Subject: Response to Technical Comments and Addendum to the Site Management Plan The Colony Development 311 2nd Street Oakland, California RO0002906/Global ID SL0600180448

On behalf of the 311 Company, LLC, Treadwell & Rollo, Inc. (Treadwell & Rollo) is pleased to provide responses to Alameda County Health Care Services Agency (ACHCSA) technical comments and an addendum to the Site Management Plan (SMP) dated 14 May 2007 prepared for The Colony Development located at 311 2nd Street in Oakland, California (Site) (Attachment A). The ACHCSA comments were outlined in a letter dated 7 August 2007. Our responses to the technical comments are described below, with the comments listed in bold and italics. The addendum to the SMP follows the responses to technical comments.

ATTACHMENT A Proposed Sampling Locations

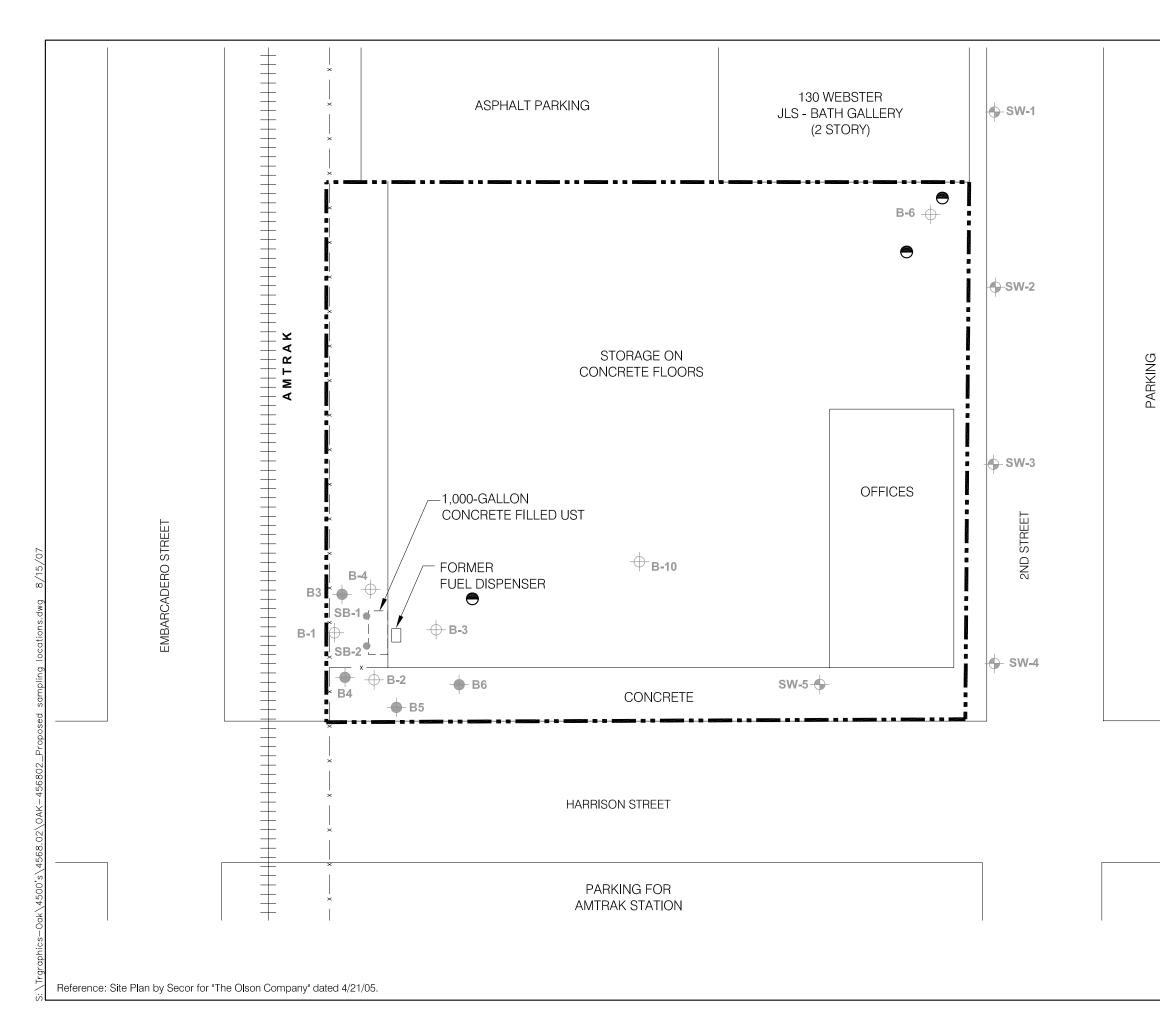
- Comment: 4) TPH contamination Total Petroleum Hydrocarbons (TPH) quantified as gasoline (TPH-g) in groundwater in boring B-3 and TPH quantified as diesel fuel (TPH-d) in boring B-6 must be further investigated. Each of these detections appear to have originated from an on-site source, which should be delineated. We therefore, recommend additional sampling up-gradient of B-3 and down-gradient of B-6. Please provide a soil and groundwater sampling plan as requested below.

- *Comment:* 6. Underground Storage Tank Soil and Groundwater Contamination We understand that the closed-in-place UST will be removed as part of the site redevelopment activities. Although unspecified in location and number, soil and groundwater samples will be collected at this time. We recommend sampling consistent with the Minimum Verification Analysis for Underground Tank Leaks used by Unidocs Member Agencies. Based upon the initial investigation by Secor from boring B-1, the initial diesel release from this tank may not be defined in groundwater. Therefore, it is unclear whether the UST closure should remain closed or the case reopened. We believe that additional sampling beyond the property boundary will be necessary to define the extent of the plume. We recommend that impacted soil and groundwater removal be done at the time of the tank removal. Please provide a map indicating additional off-site sample locations as requested below.

In addition to the excavation sampling, a soil sample and grab groundwater sample will be collected by advancing a boring northeast of boring B-3 (Figure 1) to groundwater (approximately 9 feet bgs) to further evaluate the TPH-g previously detected in groundwater -3 (5,300 µg/L). Samples will be analyzed for TPH-d by EPA Method 8015M with silica gel cleanup and TPH-mo by EPA 8015M. The groundwater sample will be additionally analyzed for TDS by EPA 160.1. Results of the soil and groundwater sampling up-gradient of boring B-3 will be included in the Completion Report. If an unknown source of contamination is revealed during excavation (i.e., an unknown tank) we will contact you and proceed according to the Contingency Plan discussed in the SMP.

Two borings will be advanced to groundwater (approximately 9 feet bgs) in the northeast corner of the Site. One boring will be located up-gradient (northeast) of boring B-6 near the edge of the Site in line with the approximate location of the former bunker oil tank used at the adjoining property (Figure 1). The other boring will be located approximately 10 feet down-gradient (southwest) of boring B-6. One soil sample and one grab groundwater sample will be collected from each boring and analyzed for TPH-d by EPA Method 8015M with silica gel cleanup and TPH as bunker oil by EPA 8015M. The groundwater sample will be additionally analyzed for TDS by EPA 160.1.
